Access Compliance Report

Public Rights-of-Way (Curb Ramps)

Intersection ID: 29229	Main Street: KORNIV_DR	Cross Street: LAUREN_KAY_CT	Location: SE
ADA ID: 85D6753ABAC0	Ramp Type: PerpDiag	Initial Pass/Fail: Fail	Overall Compliance: No
Severity Score: 25			
Codes/Mitigation Info/Possible Solution		Field Measurements/Component Compliance

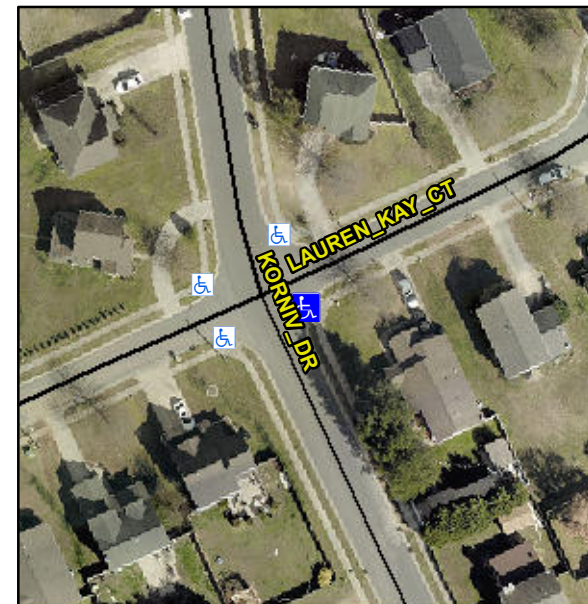
R304.2.2, R304.5.3

Compliance	Description	Data	Compliance	Description	Data
N/A	Ramp Length (in)	58.0	No	Ramp Slope (%)	10.2
Yes	Ramp Width (in)	49.0	No	Ramp XSlope (%)	5.5
N/A	Flare Type LT	N/A	N/A	Flare Type RT	N/A
N/A	Flare Slope LT (%)	N/A	N/A	Flare Slope RT (%)	N/A
N/A	Flare Traversable LT?	N/A	N/A	Flare Traversable RT?	N/A
N/A	Landing Length (in)	N/A	N/A	DWS Provided?	N/A
N/A	Landing Width (in)	N/A	N/A	DWS Contrast?	N/A
N/A	Landing Slope (%)	N/A	N/A	DWS Length (in)	N/A
N/A	Landing X Slope (%)	N/A	N/A	DWS Full Width?	N/A
N/A	Landing Curb? (Y/N)	N/A	N/A	DWS Offset (in)	N/A
N/A	Shared Landing?	N/A			
N/A	Gutter Ponding?	N/A	N/A	Gutter Slope (%)	N/A
N/A	Gutter Lip Ht (in)	N/A	N/A	Gutter X Slope (%)	N/A
N/A	Painted X Walk1?	No	N/A	Painted X Walk2?	No
	X Walk 1 Direction	To N		X Walk 2 Direction	To W
N/A	X Walk 1 Width (in)	N/A	N/A	X Walk 2 Width (in)	N/A
	X Walk 1 Slope (%)	0.5		X Walk 2 Slope (%)	1.9
	X Walk 1 X Slope (%)	2.8		X Walk 2 X Slope (%)	2.2

Remove & Replace Curb Ramp With Two New Directional Ramps or Equivalent.
